Project #21-053 Old Ephraim Apartments Located at approximately 655 East 400 North

Project Name: Proponent / Owner: Project Address: Request: Current Zoning: Type of Action: Hearing Date Submitted By: Old Ephraim Apartments Nathan Whittaker / GBN Enterprises LLC & KSF Prop. LLC 655 E. 400 N. Design Review Permit Campus Residential (CR) Quasi-Judicial September 9, 2021 Russ Holley, Senior Planner

Staff recommends that the Planning Commission **conditionally approve** a Design Review Permit for Project #21-053, Old Ephraim Apartments, in the Campus Residential (CR) zone located at approximately 655 E. 400 N., TIN #06-058-0005; -0006; -0003; -0004.

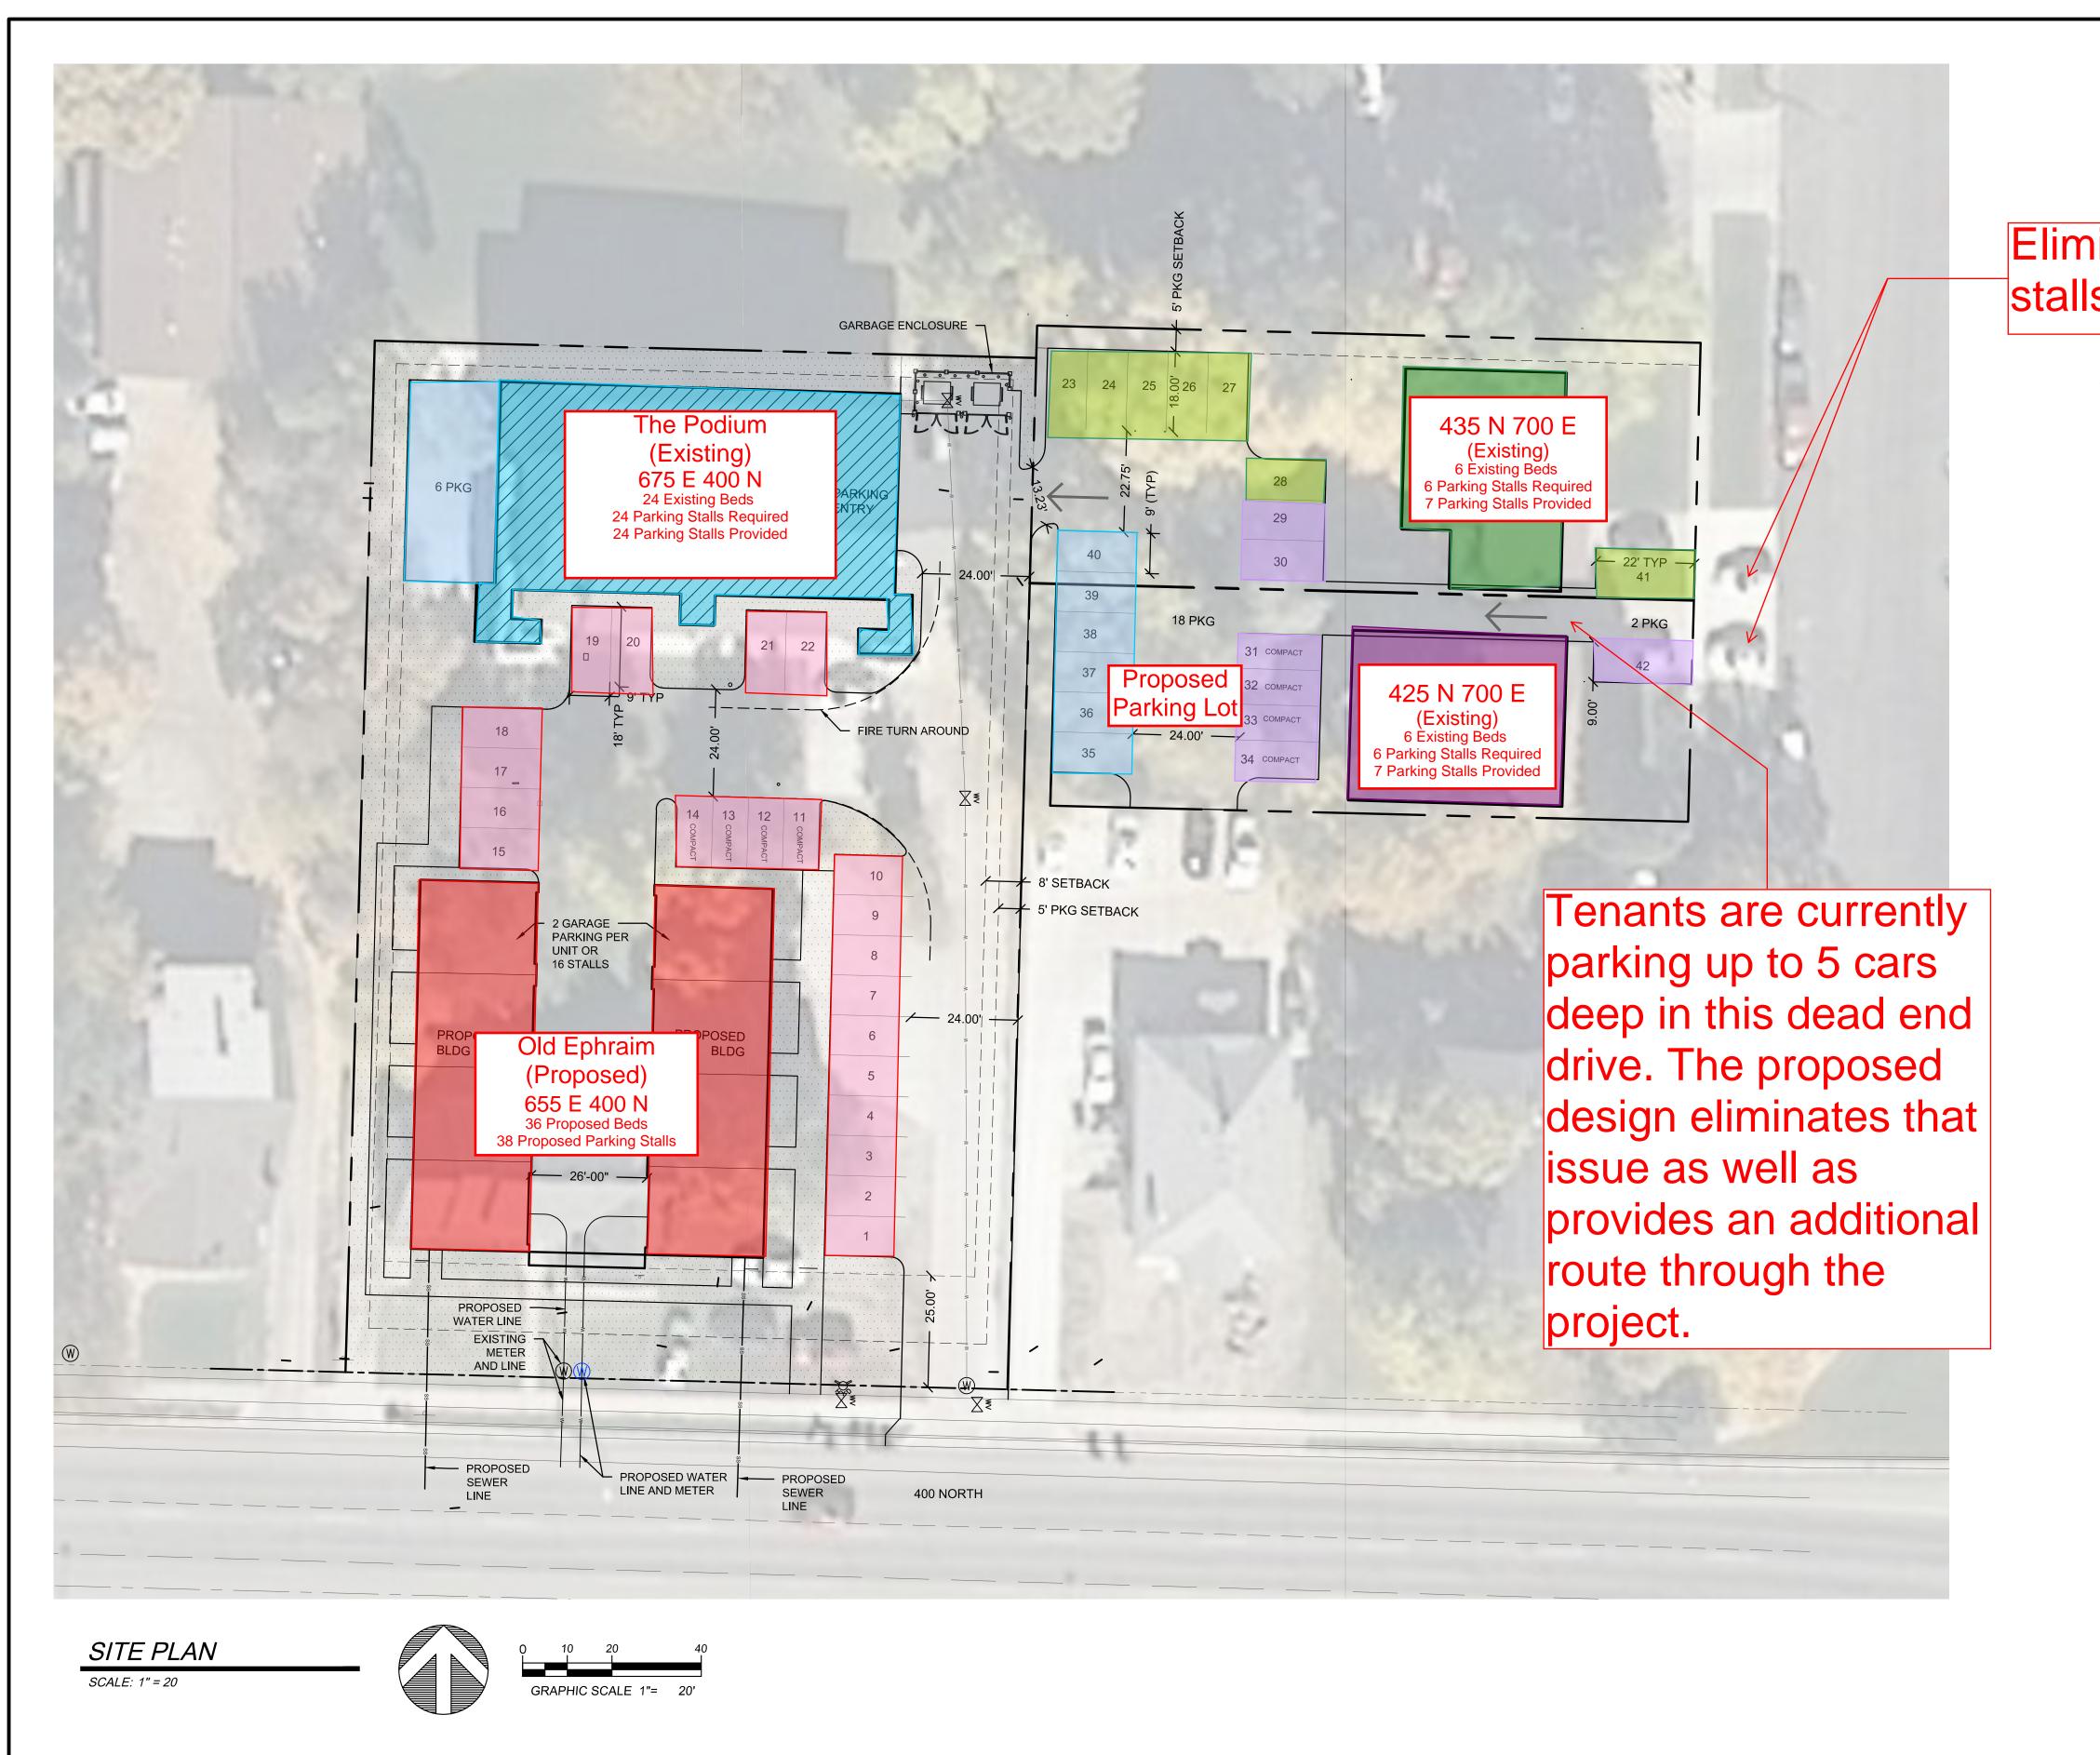
Eliminate existing stalls in mow strip.

SITE PLAN

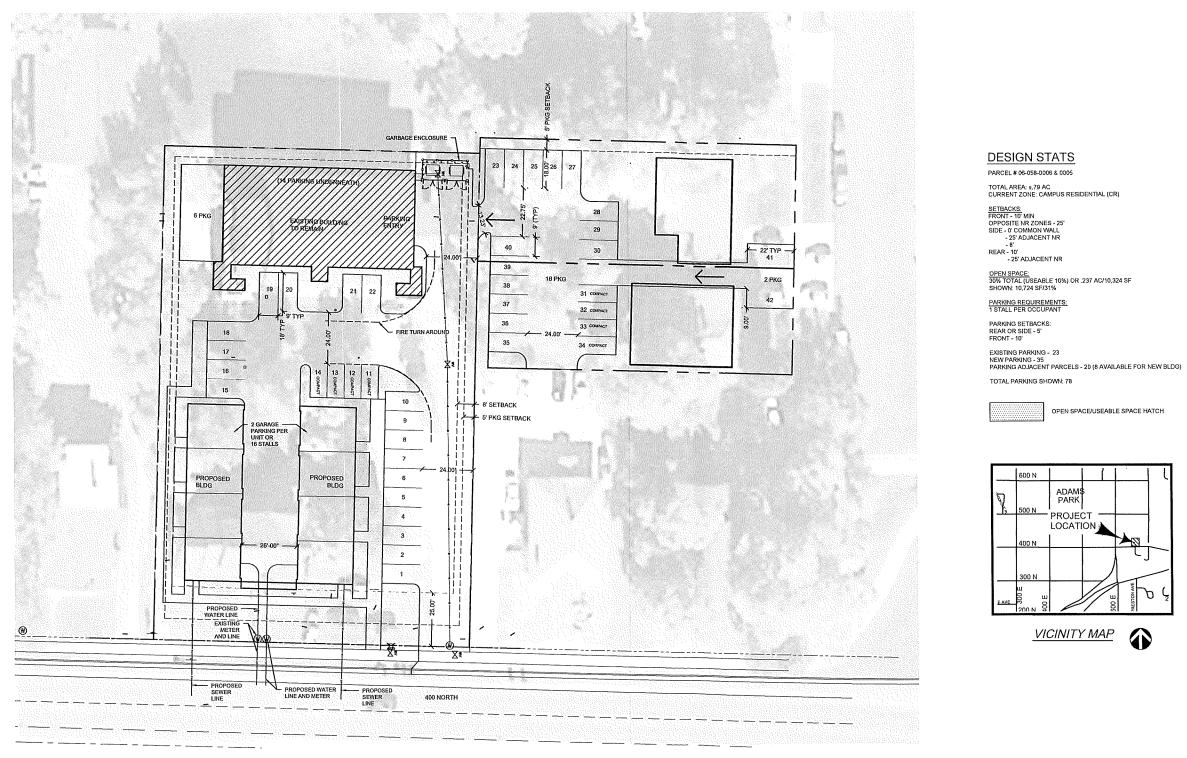
- Minimum 60 ft. straight on access required. Approach must be level, no down or uphill slopes.
- Minimum inside measurement for a double enclosure is 24 ft. wide by 10 ft. deep. Minimum inside measurement for a single enclosure is 12 ft. wide by 10 ft. deep.
- Place bollards in the back of enclosure to protect walls.
- Gates are not required, however if desired, they must be designed to stay open during the collection process.
- Barrel hinges are suggested for the gates. We need the full 12 ft. clearance so gates must be designed to open completely.
- Current enclosure needs to be shifted to the East so both bins are accessible straight on from driveway.
